# **Explanation of Significant Differences to the Final Record of Decision for Parcel C**

**Hunters Point Shipyard  
San Francisco, California**

**October 2014**

**RESPONSE TO COMMENTS ON  
DRAFT EXPLANATION OF SIGNIFICANT DIFFERENCES TO THE  
FINAL RECORD OF DECISION FOR PARCEL C, HUNTERS POINT NAVAL  
SHIPYARD, SAN FRANCISCO, CALIFORNIA**

**FIGURE 2-2**

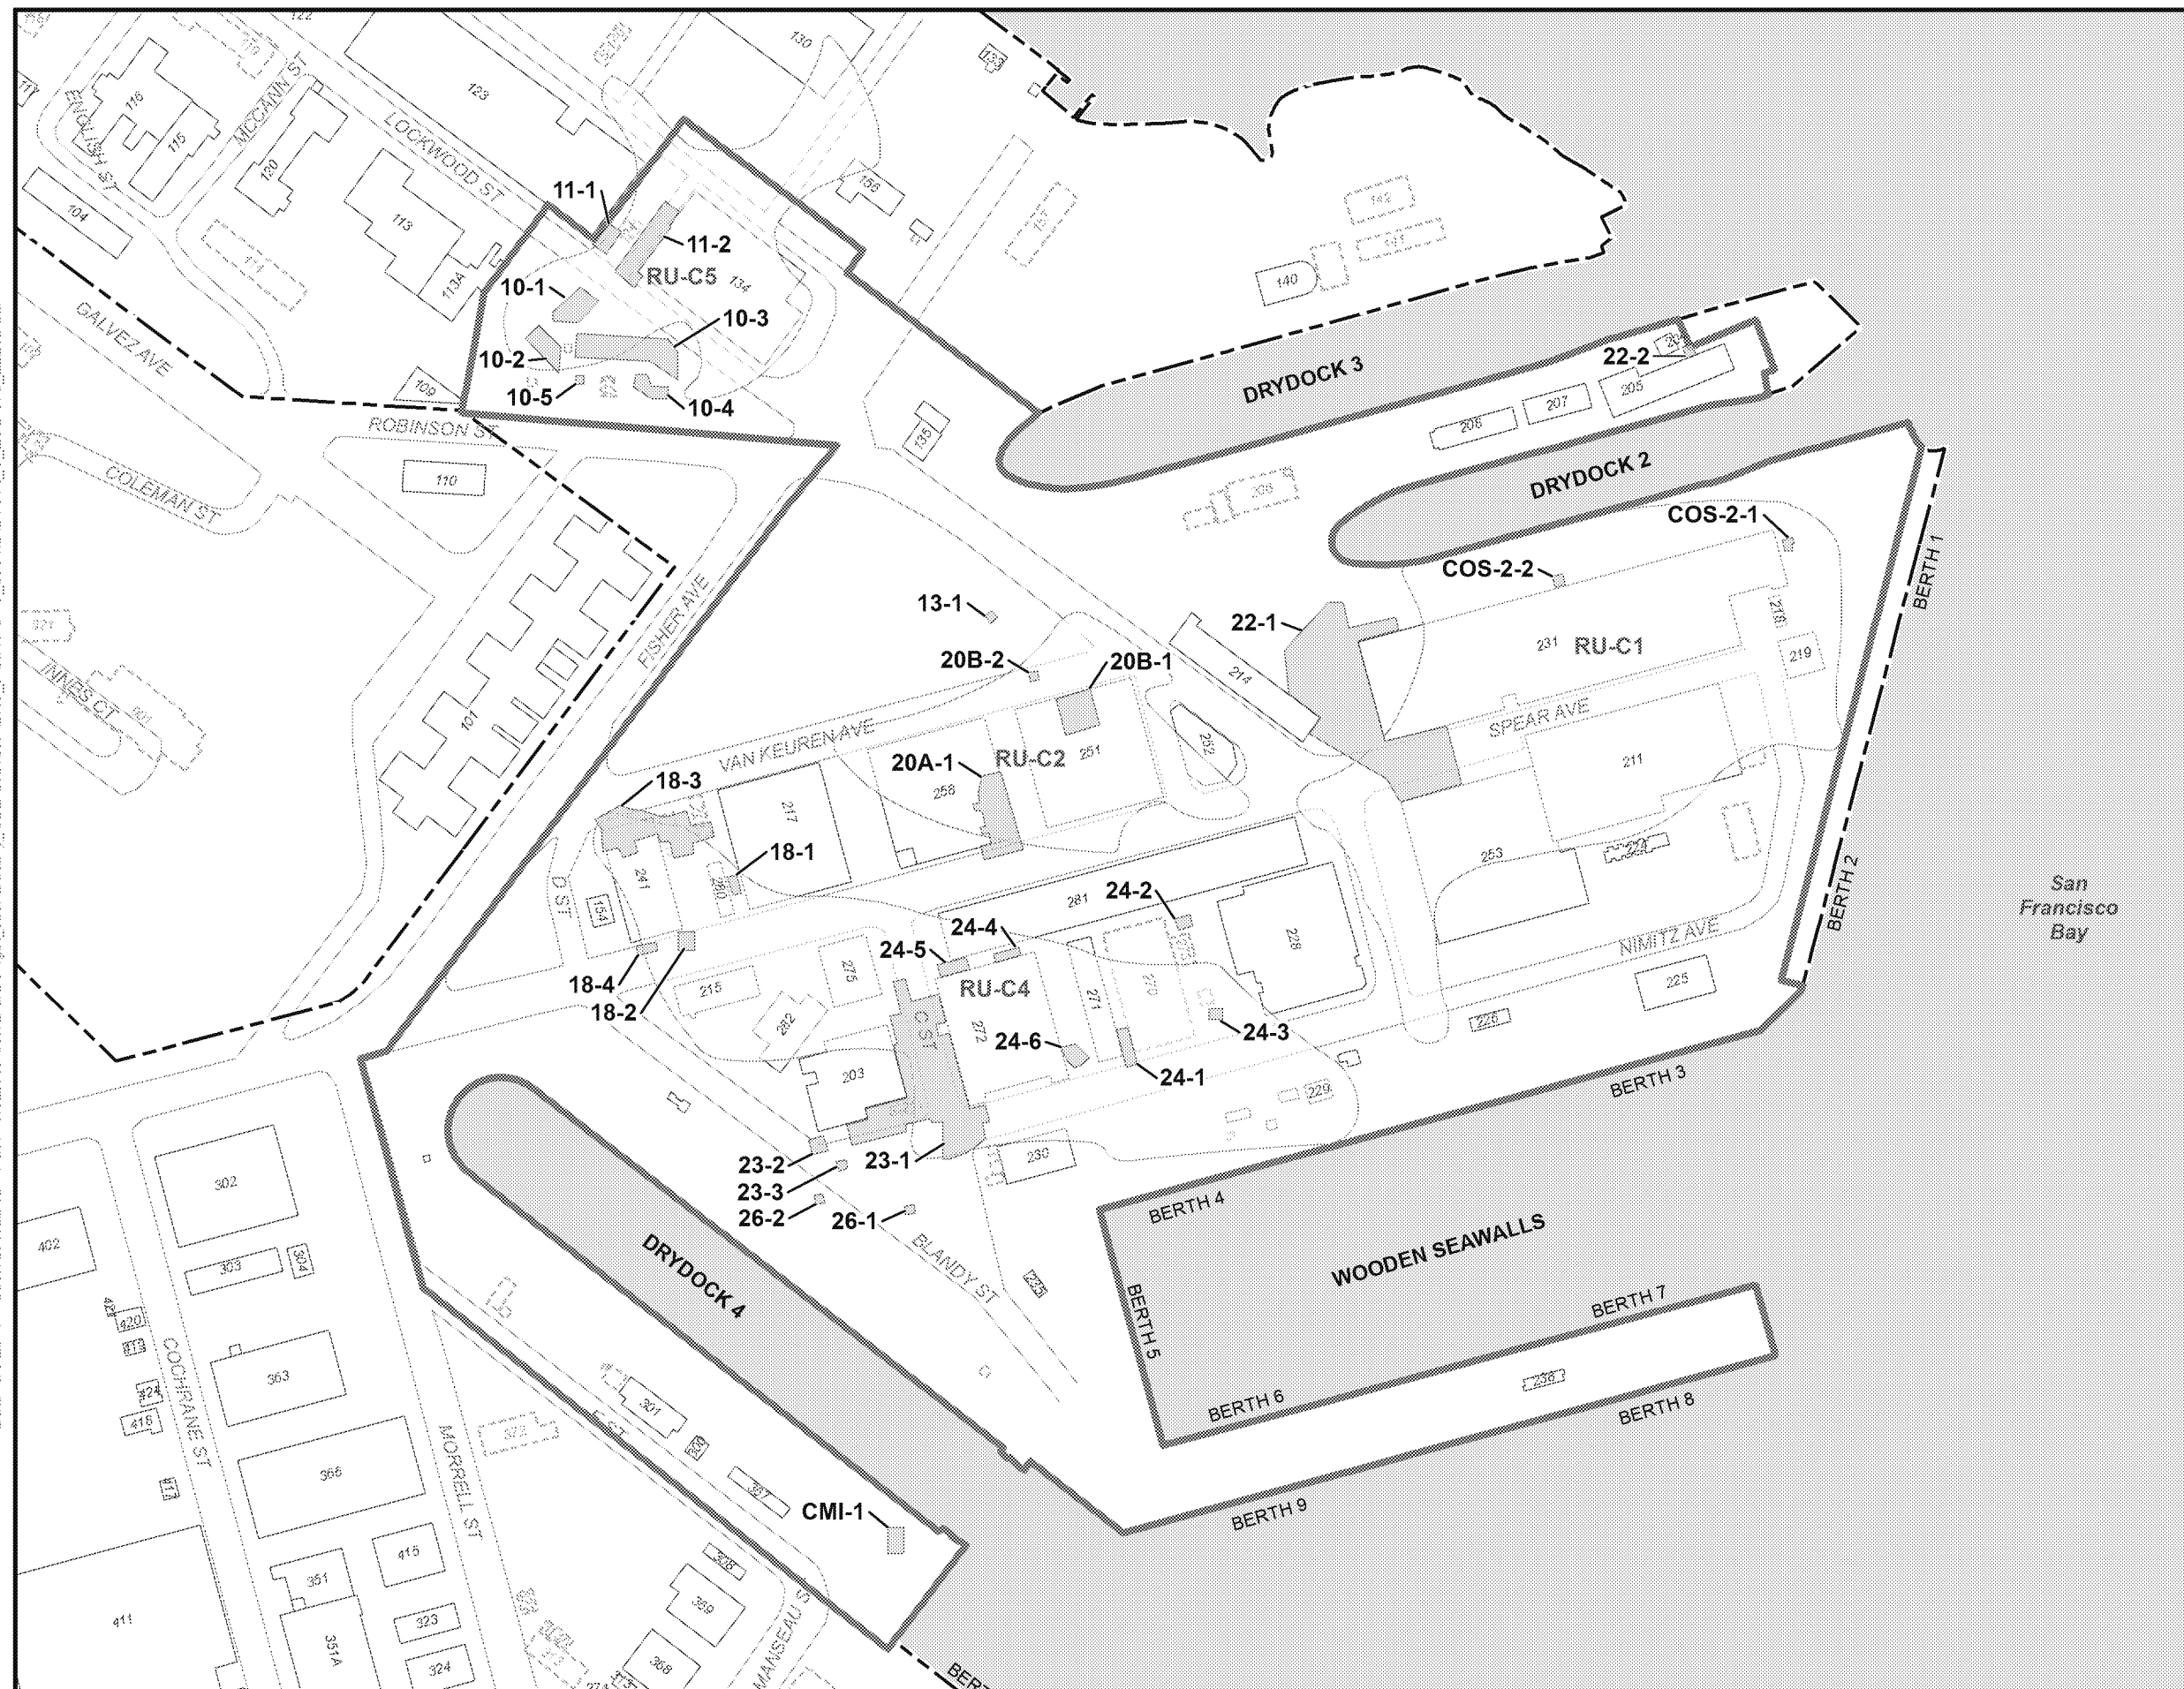
Comment Number	Section/ Page	Comment	Response
1.	<b>Section 2.2.1 – Site Risks for Soil.</b>	<p>(a) Given that the previous section 2.2 states that “limited viable habitat is available for terrestrial wildlife at Parcel C because most of the site is covered with pavement”, it is unclear why “root uptake” is listed as a primary fate and transport mechanism in the text. Please either further explain the basis for this mechanism’s inclusion or consider removal from the presented text.</p> <p>(b) Third paragraph. The text presents a summary of the revised Human Health Risk Assessment results for soil. Please consider adding a figure to the document that identifies the locations of the redevelopment blocks discussed and reference this figure in the text accordingly.</p>	<p>(a) Root uptake is indicated as a transport mechanism in Section 2.2.1 because ingestion of homegrown produce by residential receptors was evaluated as a potential exposure pathway in the human health risk assessment (HHRA). Although a durable protective cover will be placed on Parcel C, this pathway was included in the HHRA to address potential future exposures. Because this section of the Explanation of Significant Differences (ESD) summarizes the site risks for soil as presented in the Record of Decision (ROD), root uptake will be left in Section 2.2.1 as one of the transport mechanisms included to estimate site risks (e.g., ingestion or dermal contact).</p> <p>(b) A sentence was added to the third paragraph of Section 2.2.1 to reference Redevelopment Blocks shown in Figure 2-2.</p>

4.	<b>Section 2.2.1, Site Risks for Soil, page 2-2, 2nd full paragraph</b>	Redevelopment blocks are referred to in the text but are not shown on a figure. Consider including a figure showing land use and redevelopment blocks used in baseline HHRA.	The redevelopment blocks were added to Figure 2-2. Please also see the response to DTSC Comment 1.

1.	<b>Figure 2-2, Parcel C Location</b>	Should blue dashed line for “Groundwater Plume Area” be removed from Legend?	Thank you for your comment. We believe that showing the groundwater areas is beneficial to the overall figure.

FIGURE 4-10

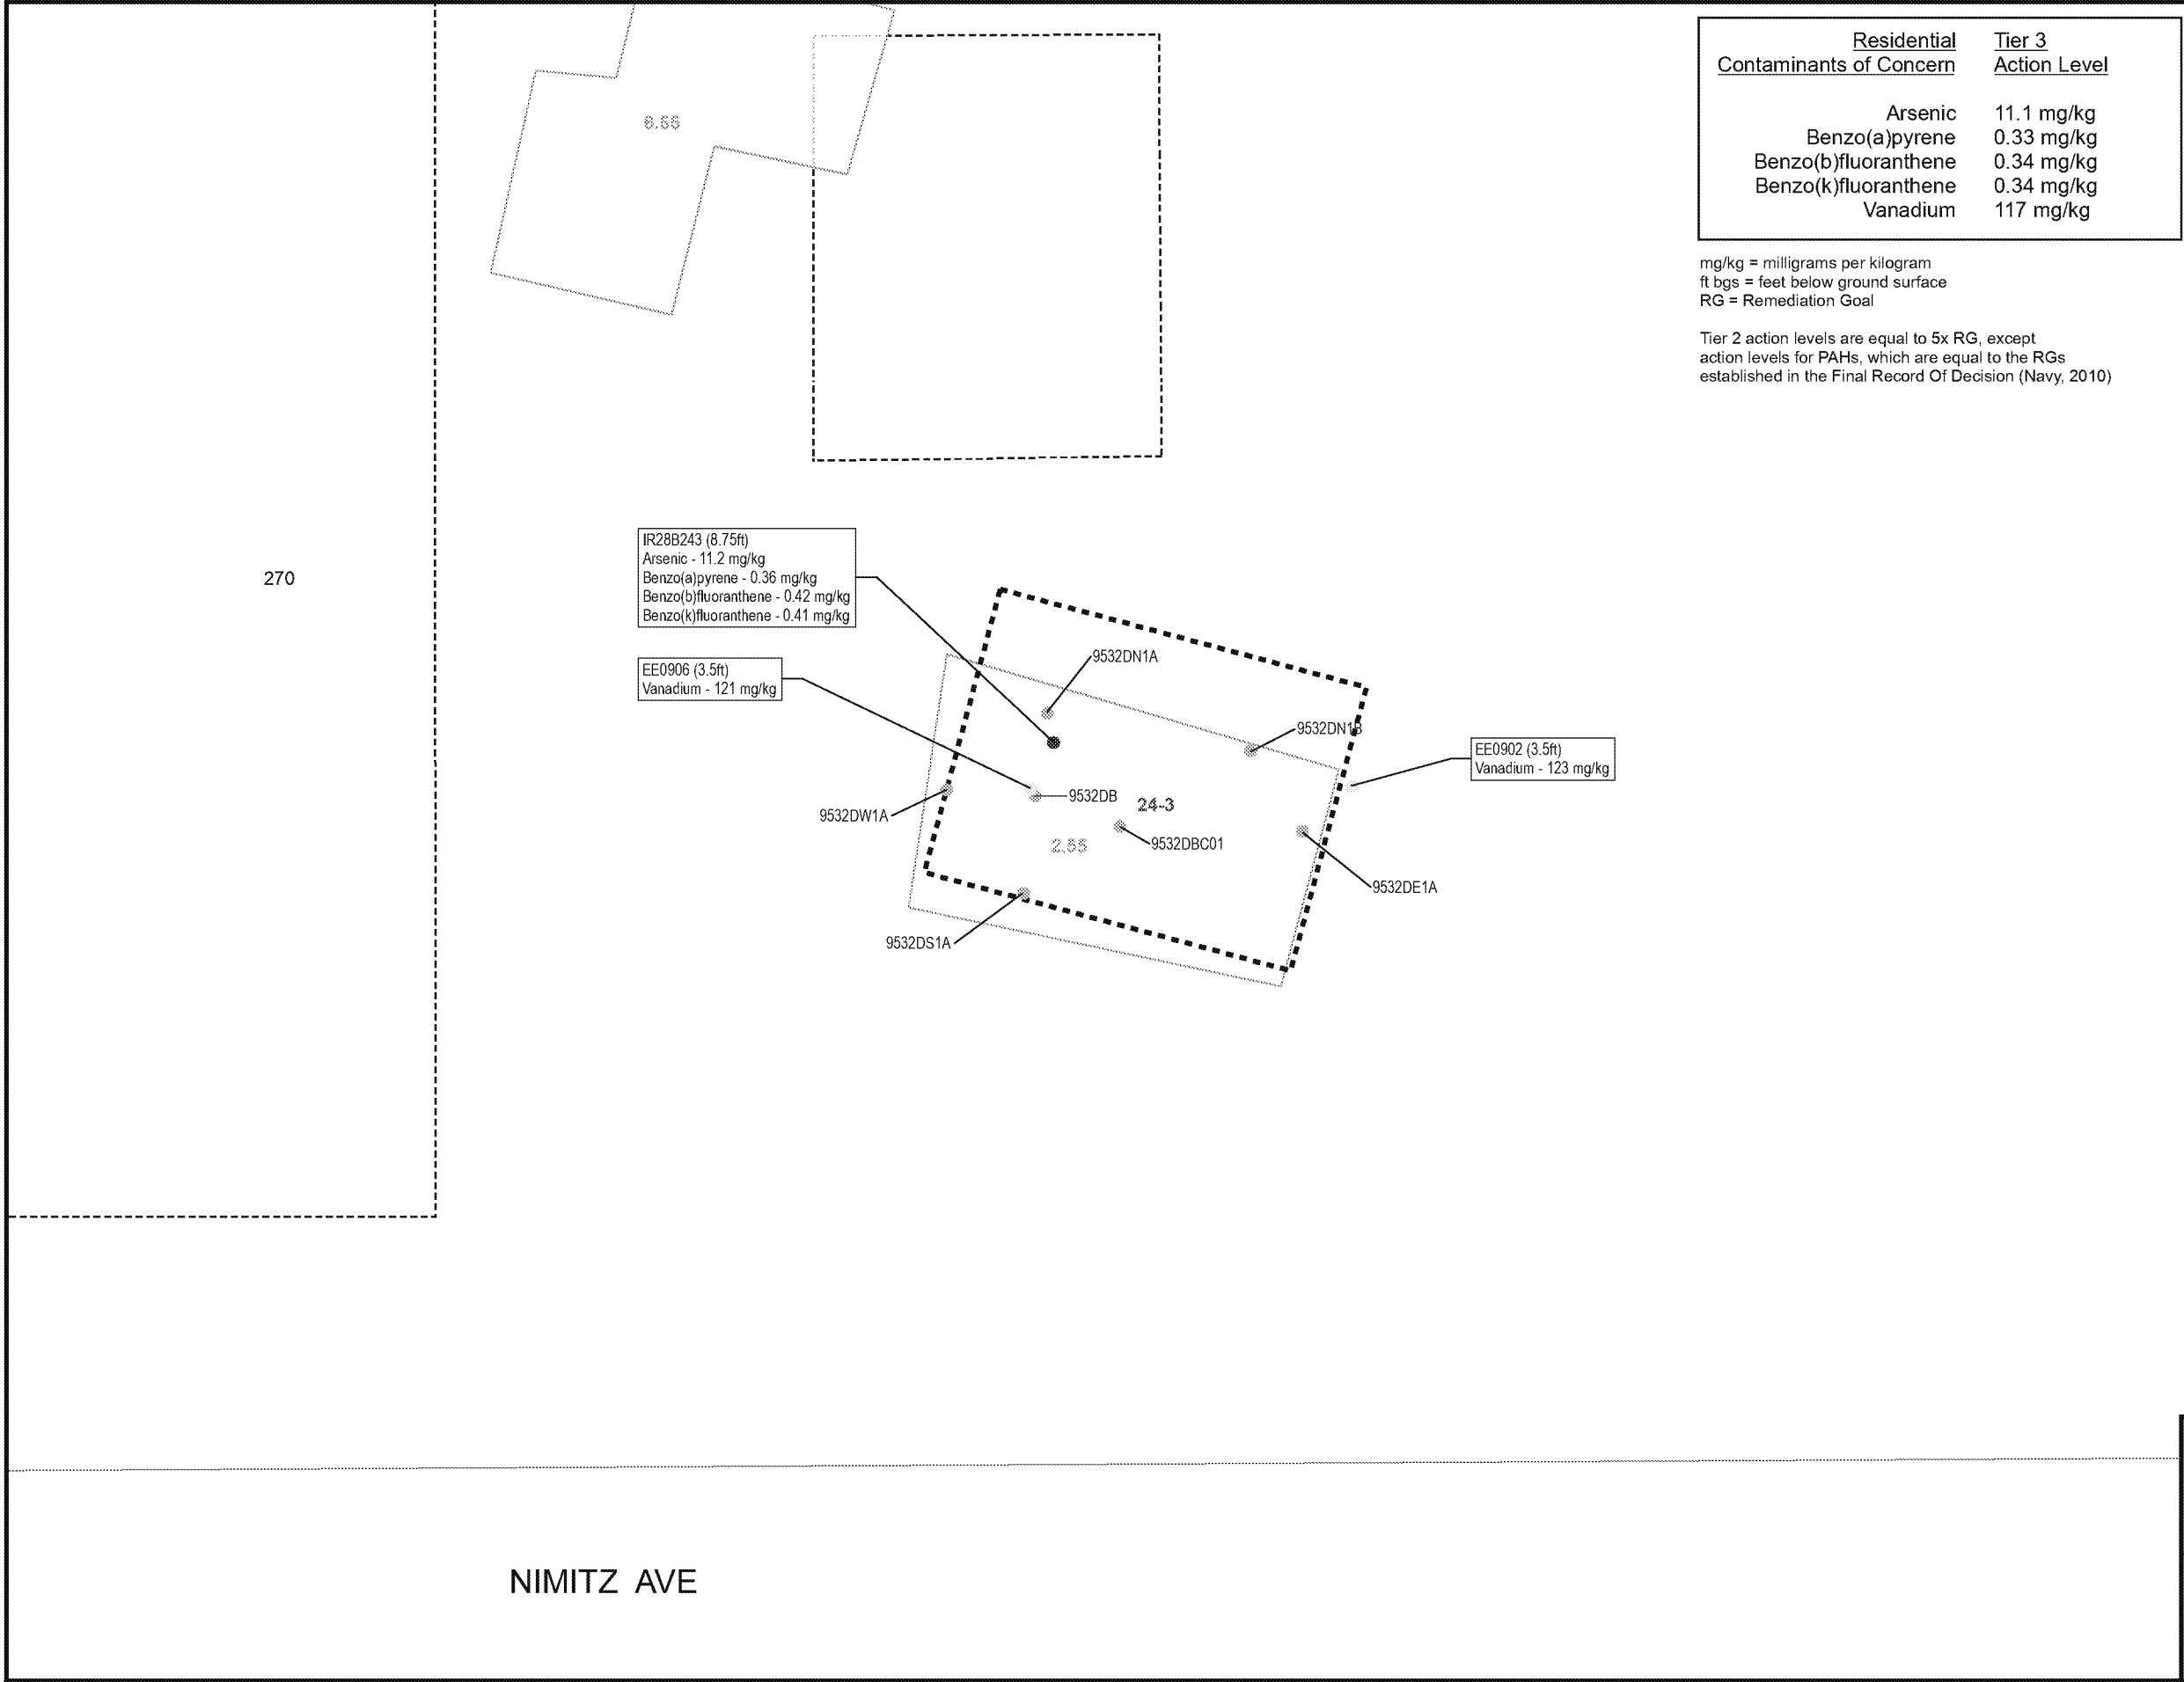
Comment Number	Section/ Page	Comment	Response
3.	<b>Section 4.2.2 – RU-C4.</b>	(a) Soil Excavation 23-1 subsection. The text states that the areas identified in Figures 4-4 through 4-11 are proposed to be excavated to a minimum of 1 foot deeper than samples exceeding Tier 1 action levels. However, on Figure 4-10, sample number 290109W6D has a Tier 1 action level exceedance for both benzo(a)pyrene and copper at 3 feet below ground surface, and is not included in an excavation area. The adjacent excavation to 4 feet below ground surface should be expanded to include this location accordingly.	(a) Sample number 290109W6D does show an elevated level of benzo(a)pyrene of 0.35 mg/kg compared to a Tier 1 action level of 0.33 mg/kg. However, copper at 650 mg/kg is less than the Tier 1 action level of 1,600 mg/kg. Excavation area 4 will be expanded to include sample number 290109W6D for benzo(a)pyrene (Figure 4-10).

6.	<b>Figure 4-10, Tier I Excavation Area 23-1 (Sheet 7)</b>	Location 290109W6D is denoted with a red dot, indicating that the soil sample collected from 3 feet bgs at this location exceeded the RG for PAHs, but it is not included within an excavation area. EPA requested excavation of this area at the meeting where the tiered approach was discussed. Please ensure this location is excavated.	The area where Sample number 290109W6D was collected was excavated as part of the Remedial Action. This was verified with the excavation contractor. The figure will be updated to reflect excavation in this area.
